CITY OF LITCHFIELD PARK

DESIGN REVIEW BOARD

DATE: August 1, 2019

SUBJECT: Applications for Review by the Design Review Board (DRB)

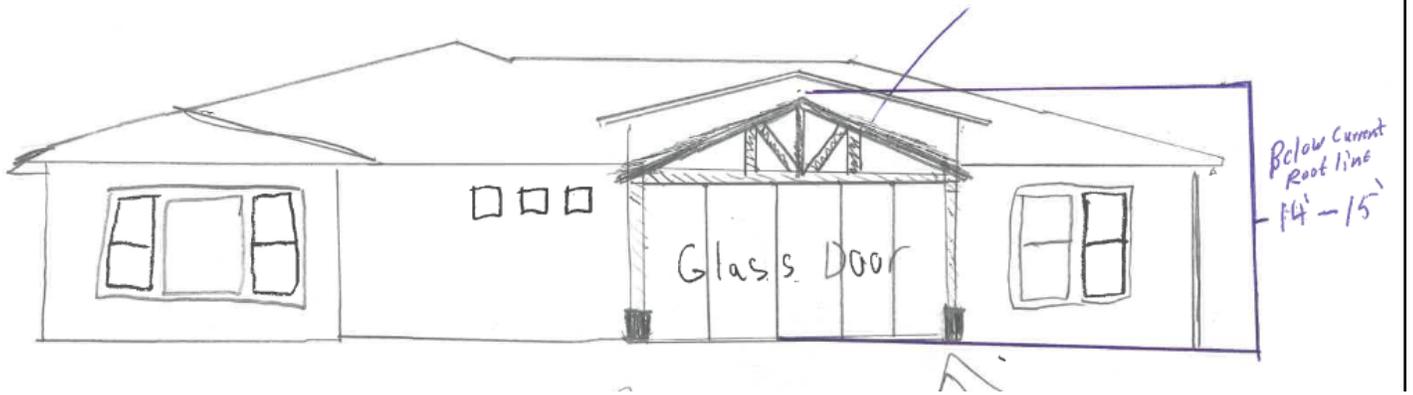
Generally, Staff can approve minor rear patio additions to a home without DRB approval, so long as the proposal is clearly conforming with setback requirements, colors and materials matching the existing residence, and compatible architecture. The proposal for this property is a relatively unique and large patio structure with exposed trusses and a rural theme. The elevation exhibit notes that the roof pitch will match that of the home, but the photo provided identifies a metal roof and wood columns. The home is

stucco with a concrete tile roof. It is not ultimately clear how the proposed structure will be modified to blend as a natural appearing extension of the existing residence.

This said, the HOA shares the same concerns as the City in regards to colors/materials/finishes and roof pitch. The applicant will need to provide additional details at the hearing concerning how they plan to conform with both the City's requirements for the addition as well as those stipulated by the HOA.

Staff finds that the proposed patio addition, while adding an amenity to the rear yard of the residence, needs the owner's clarification of the items left outstanding regarding the project. Staff will make a recommendation on the application once the owner clarifies these items.
